Fermi 2 Seismic Walkdown Guidance Document  
Seismic Walkdown Checklist

NJPR-12-0043

Seismic Walkdown Checklist (SWC)

Photo 1, Close-Up View of Inside of Shutdown Panel

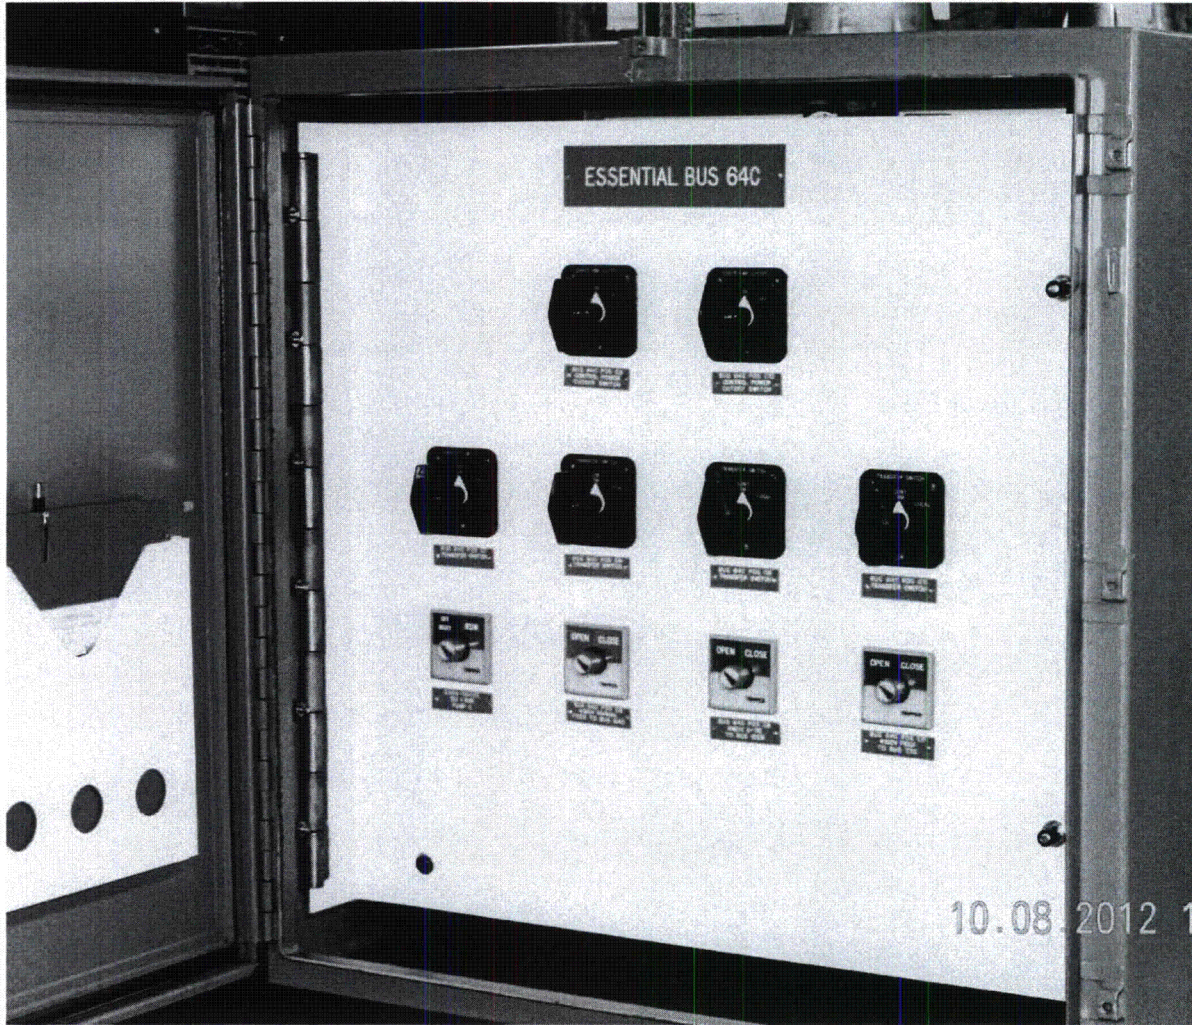
11. Have you looked for and found no other seismic conditions that could adversely affect the safety functions of the equipment?  Y  N  U  
*The door on the instrument panel was opened to permit evaluating the adequacy of fasteners securing components mounted inside. None of the components weighed more than two pounds. No adverse conditions were identified. See Photo 1, attached.*

(DSCN0303)

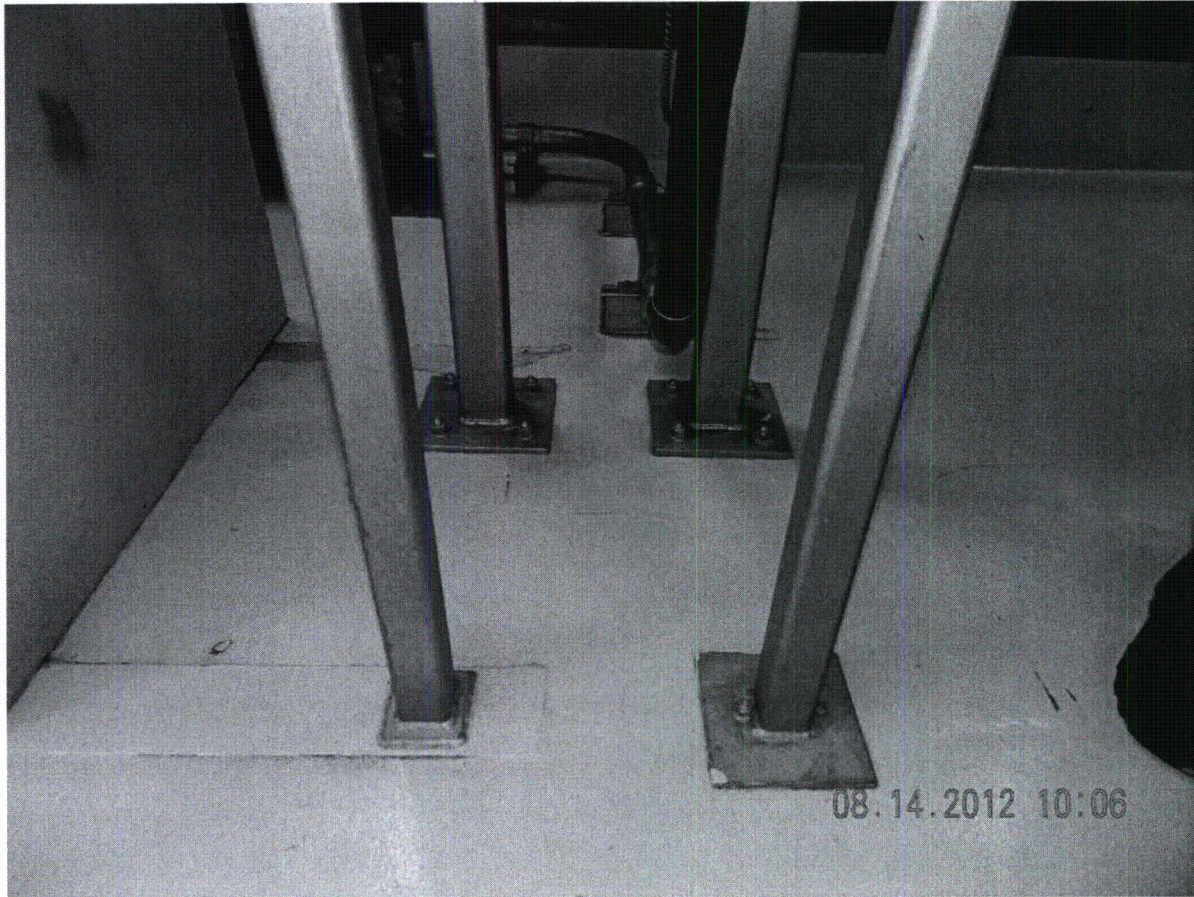
1. Is the anchorage configuration verification required (i.e., is the item one of the 50% of SWEL items requiring such verification)?  Y  N  U  N/A  
*1 welded to embedded plate and 3 welded to bolted base plate.  
(SEE PICTURES DSCN0303, DSCN0305, DSCN0306, DSCN0309) ~ DJK 10/9/12*

2. Is the anchorage free of bent, broken, missing or loose hardware?  Y  N  U  N/A  
*All base anchorage connections complete. See question No. 5 for configuration control issue.  
(SEE PICTURES DSCN0303, DSCN0305, DSCN0306, DSCN0309) ~ DJK 10/9/12*

3. Is the anchorage free of corrosion that is more than mild surface oxidation?  Y  N  U  N/A  
*Welds painted. Anchor bolts free of corrosion.  
(SEE PICTURE DSCN0303) ~ DJK 10/9/12*

Drawing has configuration error – Section G-G is incorrect for the front right leg – As-built condition is as shown on section D-D from H21P626. Verification and drawing update required (ref. Dwg. E-2998-05). CARD 12-26837 has been issued to track drawing configuration error. Welds of unistrut are consistent with drawing and welding of front legs to equipment is consistent with drawing. SEE COMMENTS ~ DJK 10/12/12  
(SEE PICTURES DSCN0303, DSCN0305, DSCN0306, DSCN0309) ~ DJK 10/9/12*

Photo 1, Close-Up View of Inside of Panel

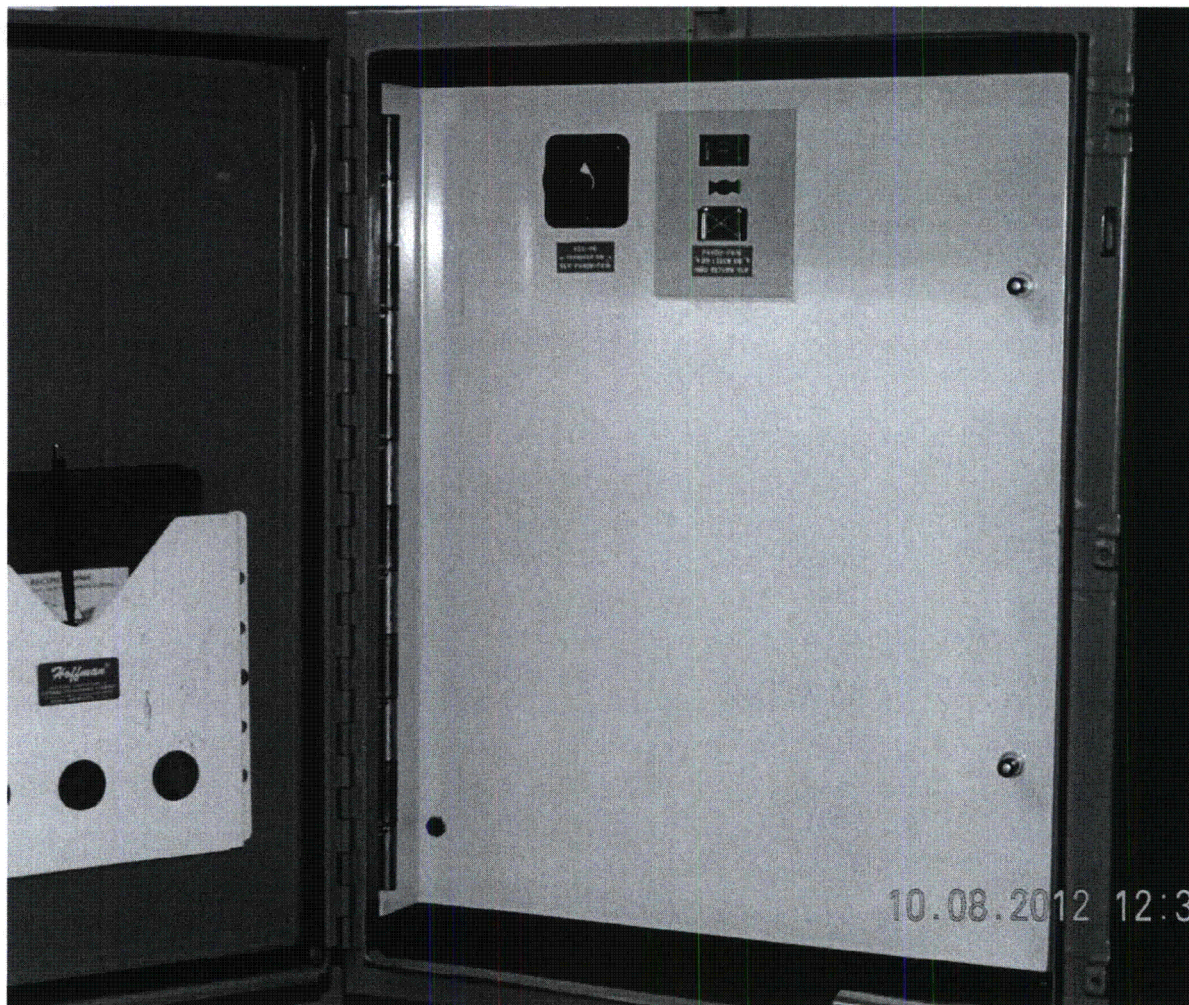
11. Have you looked for and found no other seismic conditions that could adversely affect the safety functions of the equipment?  Y  N  U  
*The door on the instrument panel was opened to permit evaluating the adequacy of fasteners securing components mounted inside. None of the components weighed more than two pounds. No adverse conditions were identified. See Photos 1, 2 & 3 attached.*

(PICTURE # 19)

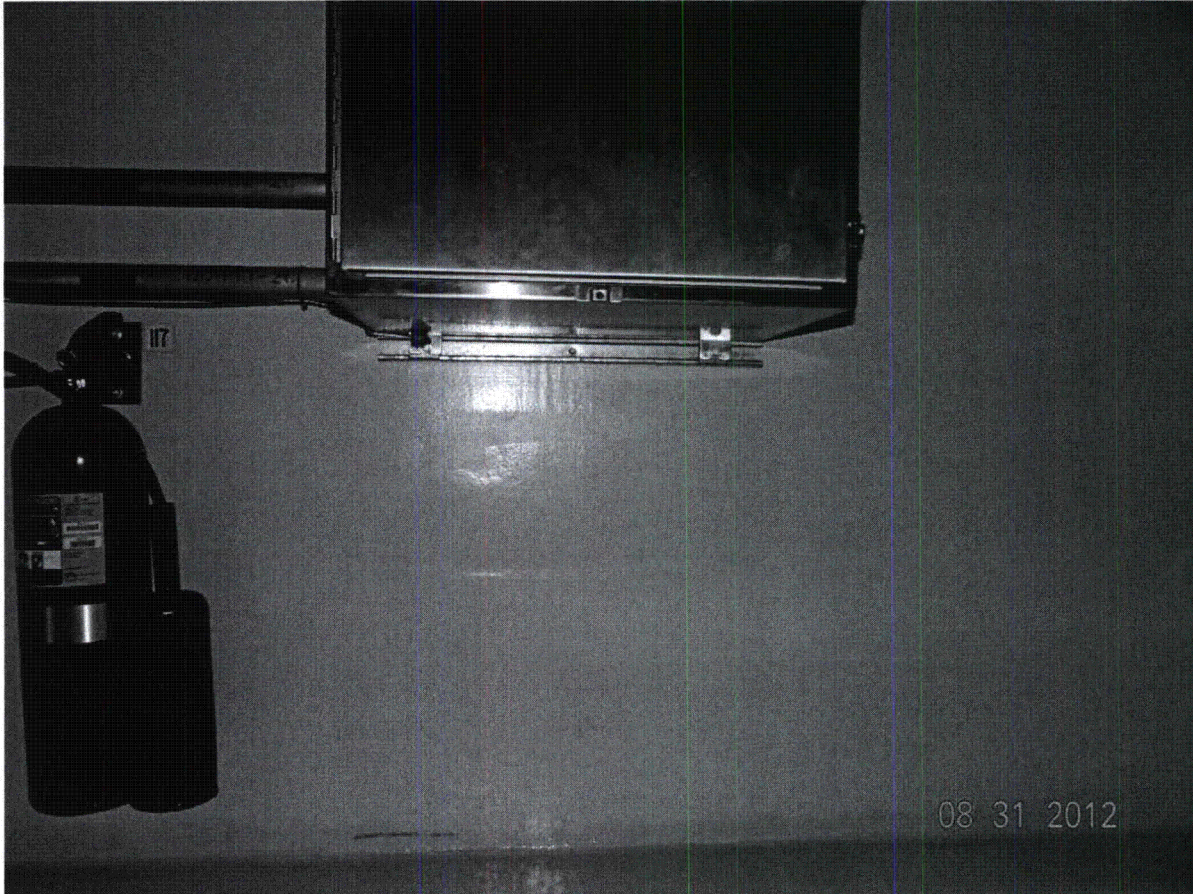
2. Is the anchorage free of bent, broken, missing or loose hardware?  Y  N  U  N/A  
*All anchorage is present and secure. See pictures 11 and 19.*

(DSC 00285)

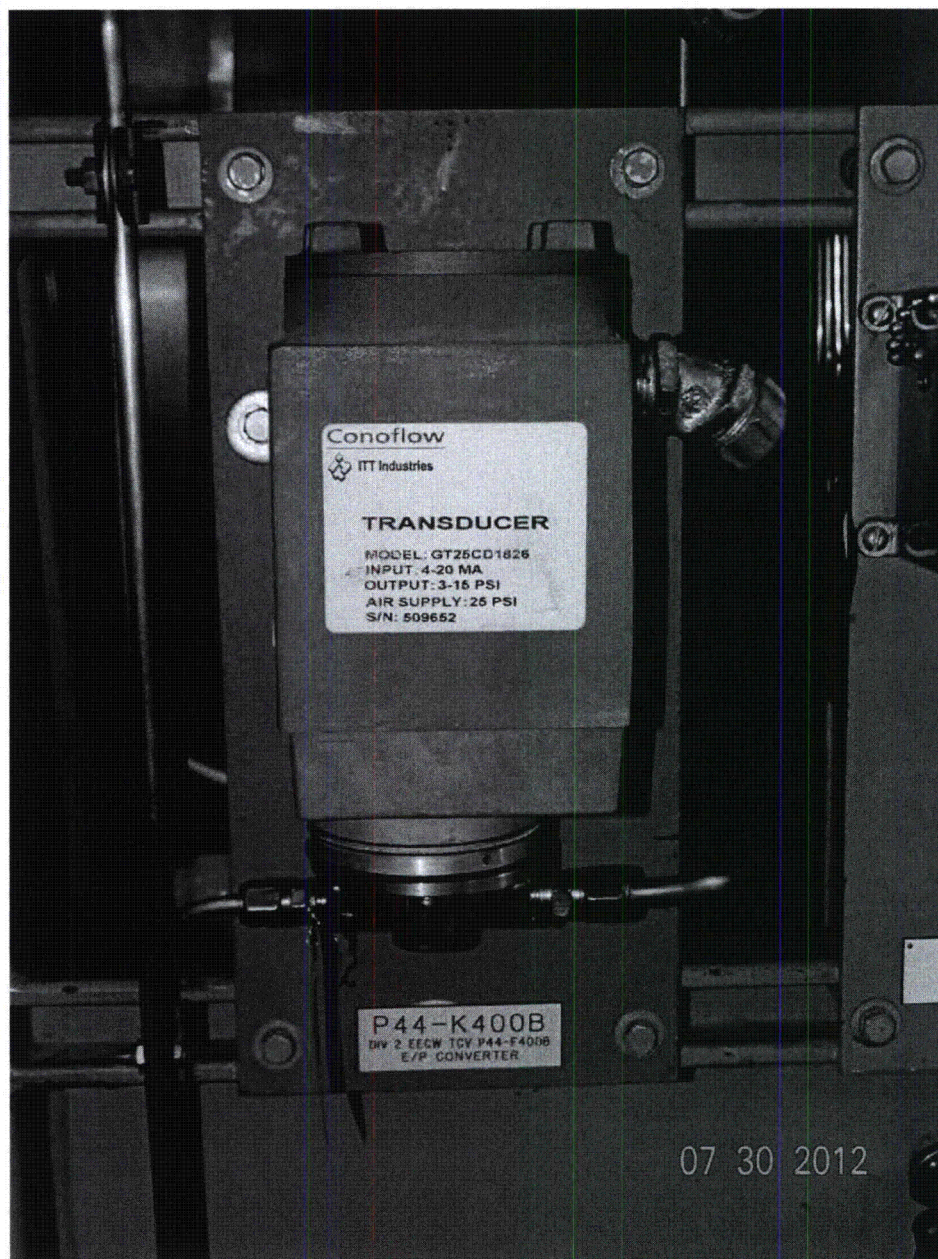
5. Is the anchorage configuration consistent with plant documentation? (Note: This question only applies if the item is one of the 50% for which an anchorage configuration verification is required.)  Y  N  U  N/A  
*Though anchorage configuration verification was not required, the transducer was determined to be bolted to the instrument rack in accordance with Dwg. I-2516-15, Rev. E, no postings (see Photo DSC 00285).*
